**ASHLAND PLANNING DEPARTMENT
PRE-APPLICATION CONFERENCE
COMMENT SHEET**
March 16, 2022

SITE: 970 Walker Street
APPLICANT: Rogue
OWNER: Foote
REQUEST: Subdivision

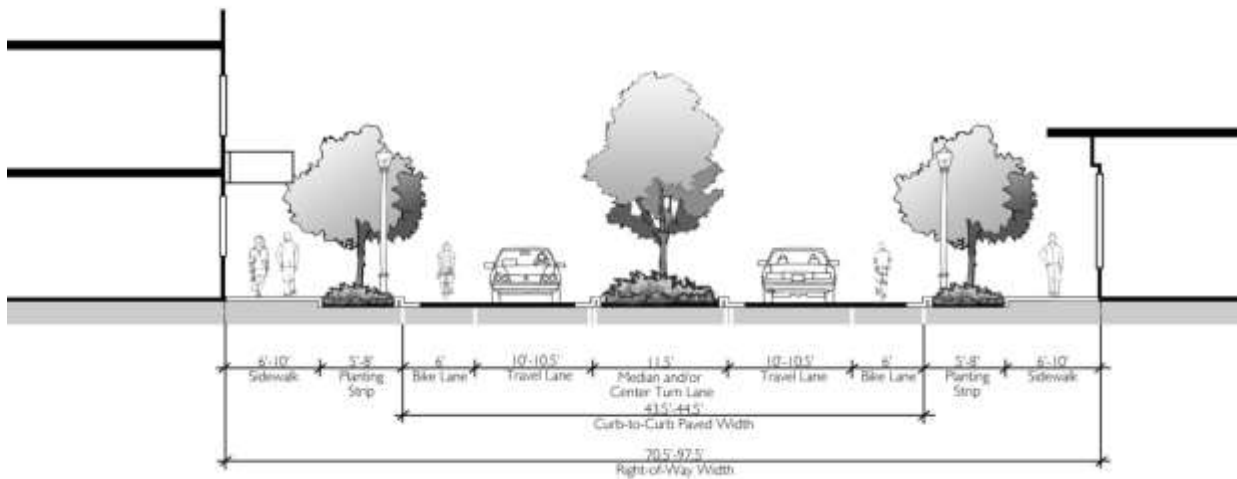
- **Parking Location & Design (AMC 18.4.3.080.C.1-.2):** The application will need to illustrate that parking is to be provide in keeping with the location and design

standards, and should account for the third visitor space required for flag lots which must be configured to turn and exist forward to the street.
